CONTINENTAL MOTORS® AIRCRAFT ENGINE

CRITICAL SERVICE BULLETIN

SUBJECT: Throttle and Mixture Control Levers

CSB08-30

Figure 1. Throttle and Control Lever Identification

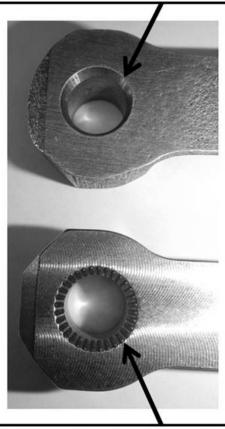
- 1. Original control levers designed for threaded shafts were manufactured from a bronze material and featured a non-machined (smooth) female chamfer on one side, which mated to the machined splined male chamfer on the throttle and mixture control shafts.
- 2. The replacement control levers are manufactured from stainless steel and feature a machined (splined) female chamfer, which interlocks with the machined splined male chamfer on the throttle and mixture control shafts (Refer to Figure 1 for control lever identification).
- 3. In addition to the levers mentioned in the paragraphs above, certain installations utilize bronze levers that are secured to the shaft with a steel pin. This bulletin does not address those installations. Refer to the applicable periodic inspection intervals in the engine Maintenance and/or Overhaul Manual.

CMI is aware that some bronze control levers were improperly installed on threaded shafts in the field, and the mechanical interlock was absent. Therefore, as part of our ongoing quality interests:

Non-Machined Chamfer. Splines formed at installation.

Machined Chamfer. Splines formed at manufacture.

All bronze control levers on threaded shafts of Continental Motors fuel injection systems must be REMOVED and REPLACED with stainless steel control levers during the next 100-hour or annual inspection or at the time a throttle or mixture control lever is removed for any reason, whichever occurs first.

Figure 2. New Stainless Steel Control Lever and Shaft

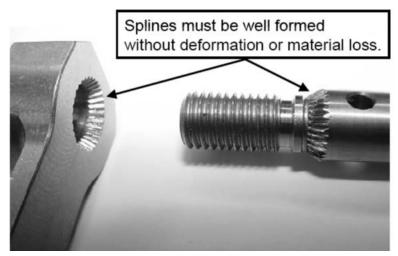
1. Inspect the component's shaft and the NEW stainless steel control lever to ensure no damaged or stripped threads exist and that the splines are well formed and without deformation or material loss (See Figure 2).

2. Install the current style, stainless steel control lever onto the component shaft, positioning the lever to allow for proper airframe control interface (consult the Airframe Manufacturer's adjustment instructions).

NOTE: The current stainless steel control levers are manufactured with machined splines that are intended to interlock with the splines on the mixture and throttle control shaft. Due to machining tolerances; the splines of a control lever and its mated shaft may not match (interlock) perfectly. However, testing has shown that control levers correctly installed and properly torqued will mate and function as intended, even if some mismatching of splines is visible.

- 3. Ensure that the splines in the control lever chamfer are meshed with the splines on the component shaft (see NOTE: above)
- 4. Lightly lubricate the control shaft threads with clean 50-weight engine oil.
- 5. Install and tighten a NEW retention lock nut on the shaft to secure the lever; rotate the lever away from the stop pin and torque the nut 100-120 inch-pounds.
- 6. Check the control lever after torque application to ensure there is no free play or movement of the control lever on the component shaft.
- 7. If free play or movement is felt after the nut is torqued to the correct value, remove the control lever and determine the cause for movement (if applicable, re-install the control lever and repeat steps 3 through 6 above. If lever continues to have free play after being torqued, replace the control lever).

Figure 3. Control Lever and Shaft Spline Inspection

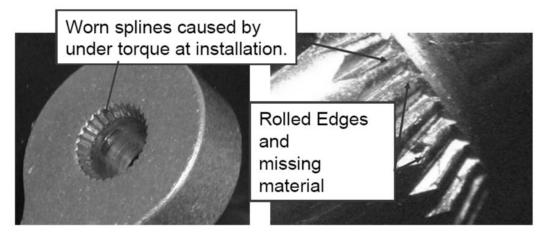
- 1. Verify the stainless steel throttle and/or mixture control levers are securely installed on the control shafts.
- 2. Inspect the installed lever(s) for looseness or free play on the shaft looseness or free play of the lever on the shaft is prohibited.
- 3. Verify the retaining nut (if used) is torqued 100-120 inch-pounds.

Any control lever or shaft exhibiting damage must be replaced prior to further service using the procedures contained in the applicable Maintenance or Overhaul Manual and this Service Bulletin.
